## Town of Seekonk, MA Planning Board

**DEFINITIVE PLAN REVIEW**  
**Winterfell – Plat 1, Lots (s) 24 (316 Warren Ave.)**

**RE: Winterfell Definitive Subdivision  
316 Warren Avenue  
Assessors Map 1 Lot 24  
Seekonk, Massachusetts  
DE Project #: 1631-009**

Re: Pine Hill Estates Subdivision.  
Cul-de-sac Modifications

**ROADWAY PROFILE PLAN**

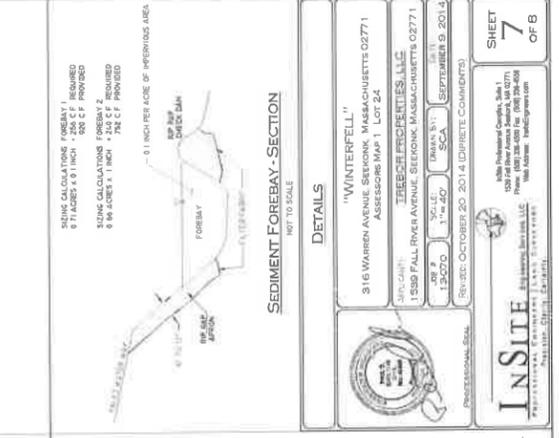
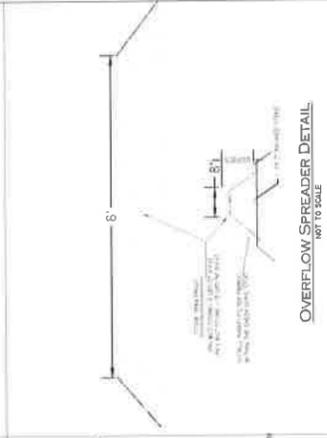
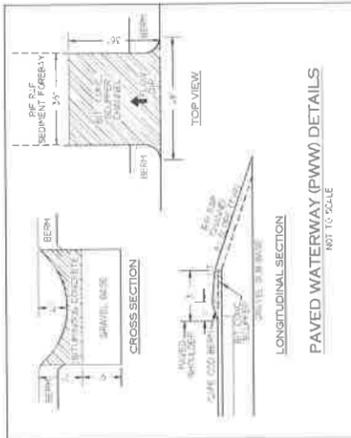
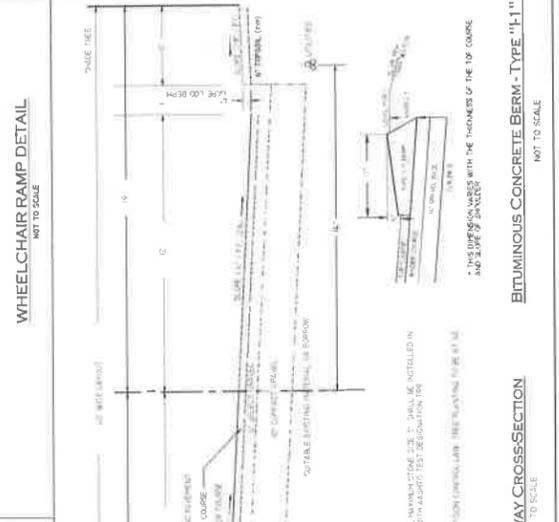
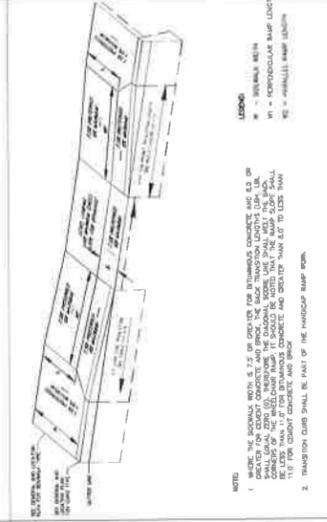
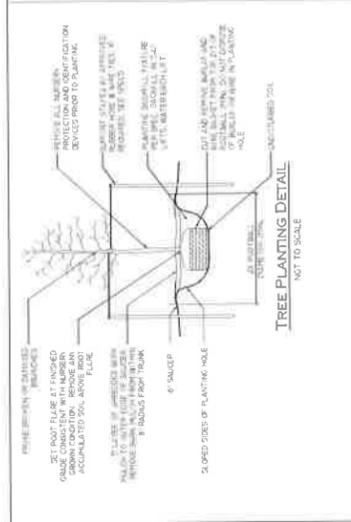
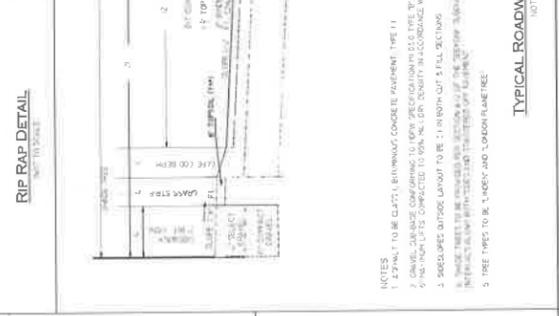
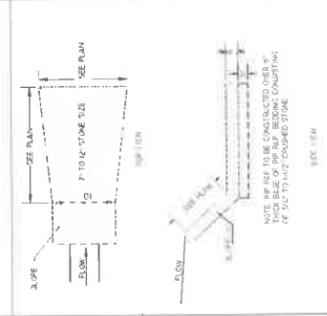
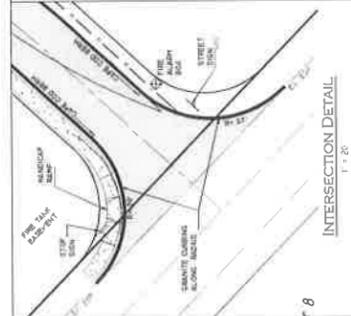
- c. 5.3, 16 – Requires that all planned underground utilities be shown. Underground utilities are shown on the proposed profile view on Sheet 5, however, the layout of the proposed underground utilities is not shown on the plan view.

- e. 5.3, 17, 3 – Requires that the proposed profile show elevations every 25 feet along vertical curves. Elevations are shown at a 50 foot interval.

- a. 7.2.1.5 – DE recommends that the centerline radii be labeled on the plans to show that minimum curve centerline radii requirements are met.

*The proposed underground utilities have been added to the plan view on the "Roadway Profile Plan" sheet 5 of 8.*

*InSite Response: Elevations every 25 feet along the vertical curves have been added to the "Roadway Profile Plan" sheet 5 of 8.*

*InSite Response: The Centerline radius of 250' has been labeled on sheet 5 of 8. The proposed centerline radius is greater than the minimum requirement of 150'.*

**DETAILS**

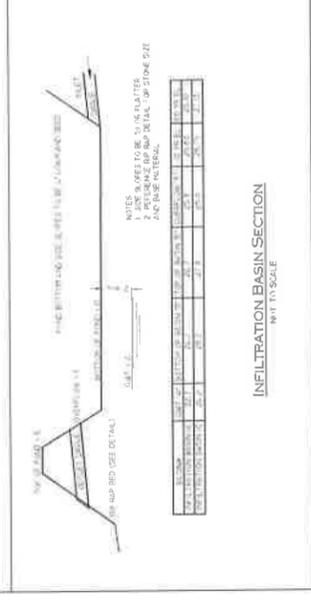
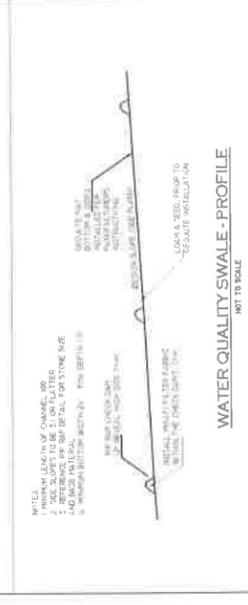
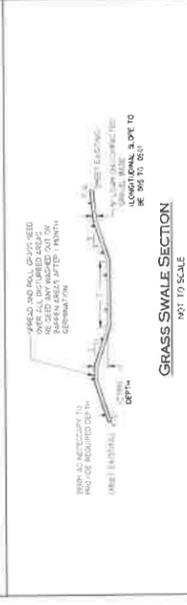
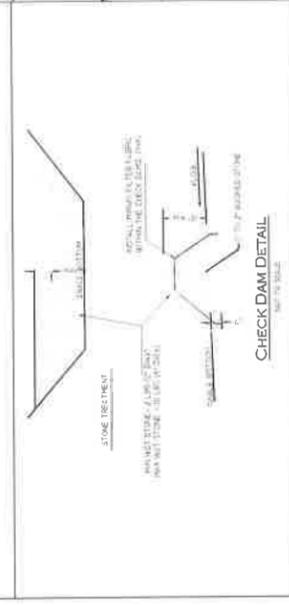
- h. 5.3, 20 – Requires proposed street trees and individual trees or wooded areas to be retained to be shown on the plans. No street trees are indicated on the plans.

- a. DE recommends that the outlet weirs for Infiltration Basin 1A and 1C be detailed on the plans.

- b. For the Infiltration Basin Section Detail the storm elevations do not match the HydroCAD analysis.

*InSite Response: A notation on the Typical Roadway Cross-Section located on sheet 7 of 8 was provided regarding the planting location and type of street trees.*

**Notation regarding location and spacing of street trees is shown on the Roadway Cross-Section detail located on sheet 7 of 8. No further comment.**

*InSite Response: A detail has been added to sheet 7 of 8*

*InSite Response: The Infiltration Basin Section, shown on "Details" sheet 7 of 8, has been revised to match the HydroCAD report.*

**The top of basin elevation for Infiltration basin C is noted as elevation 27.8 on the plans (Infiltration Basin Section detail on sheet 7) and 27.5 on the HydroCAD analysis. The elevation shown on the plans is conservative compared to the elevation used in the analysis. No further comment.**

**PLAN & PROFILE JACOBY WAY**

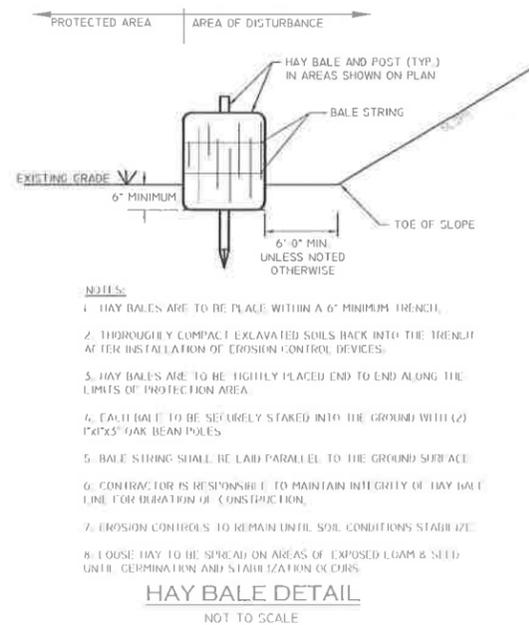
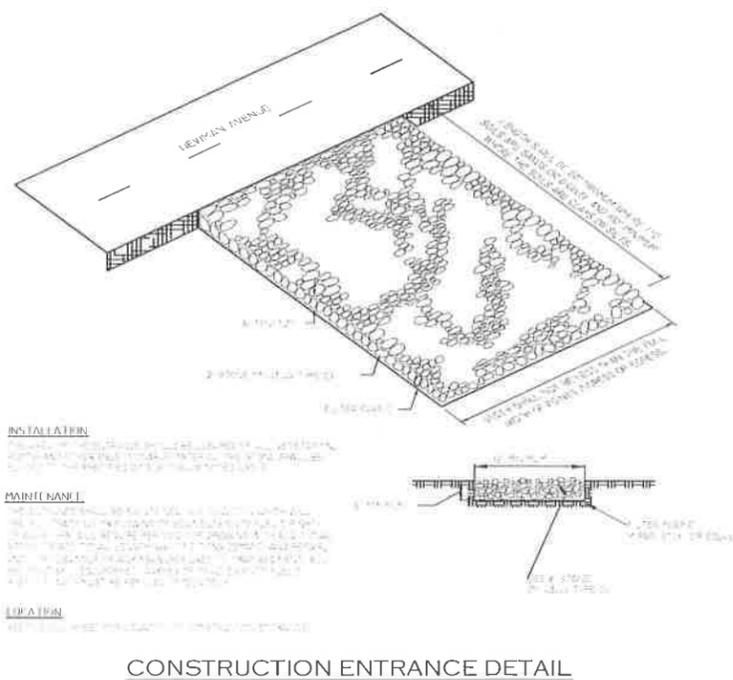
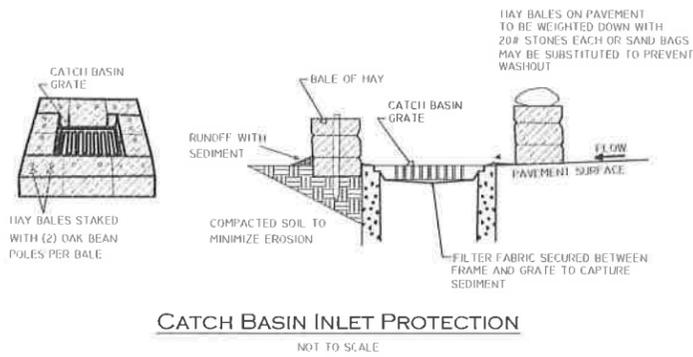
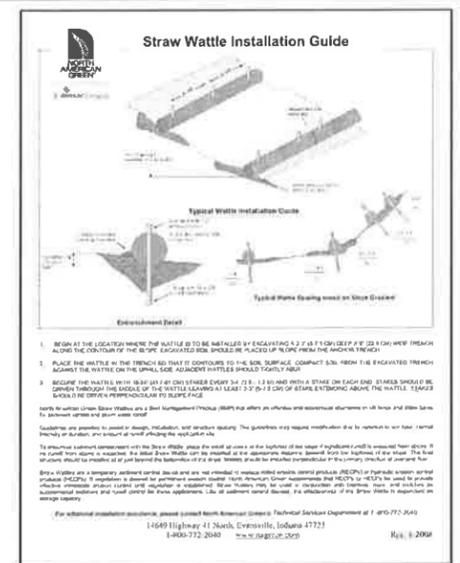
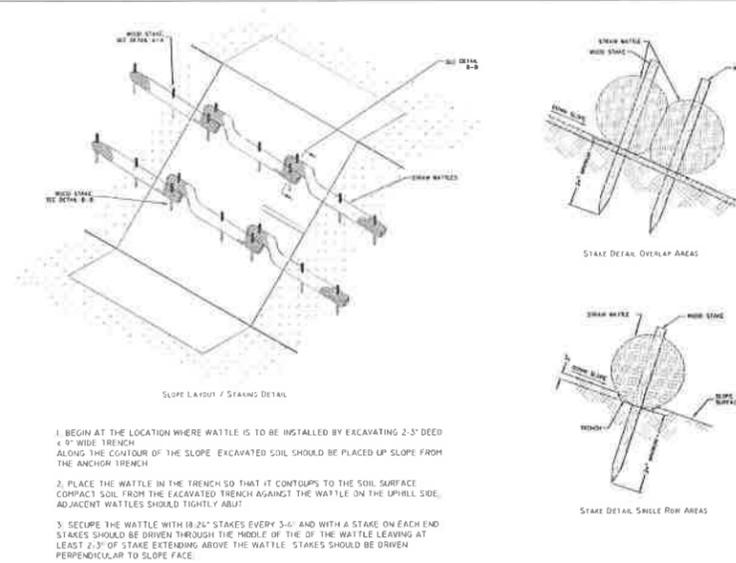
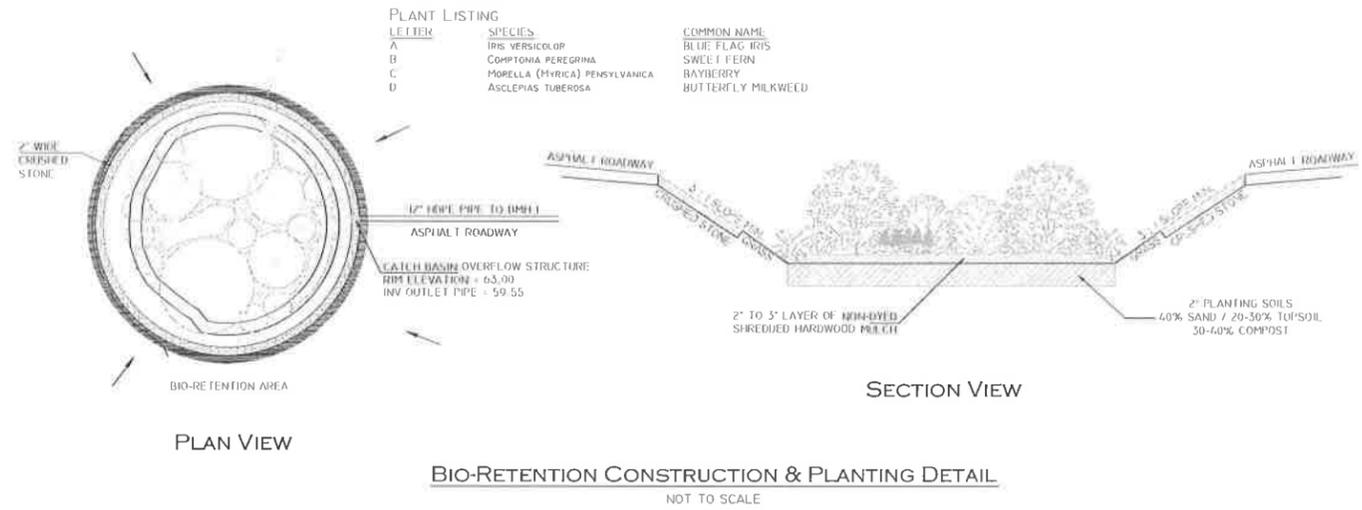
There have been a few concerns raised by the abutting homeowners, the fire chief and DPW about the narrowness of the road and depth of the bioretention basin. All parties have requested that the pavement width be expanded an additional 2' and reduce the depth of the bioretention area by 1.5'.

1. The revised modeling for the Bioretention area includes storage at elevation 62. The plans you previously forwarded do not show this contour. Is there an updated plan?

IES ran a Hydrocad model which reflects the reduced bioretention capacity and additional pavement. The Hydrocad model utilizes the original design parameters. As you can see there is no impact and the 100-year storm event still does not reach the outlet pipe.

The plan revisions and calculations furnished by IES satisfactorily addresses CEI's comments presented in the email correspondence. The latest calculations (attached) document that the design results in a peak rate of discharge to the ultimate discharge point, which is less than the peak discharge estimated for pre-development conditions, for the 100-year frequency storm.

I have attached the updated plan which had reflected those previous changes.
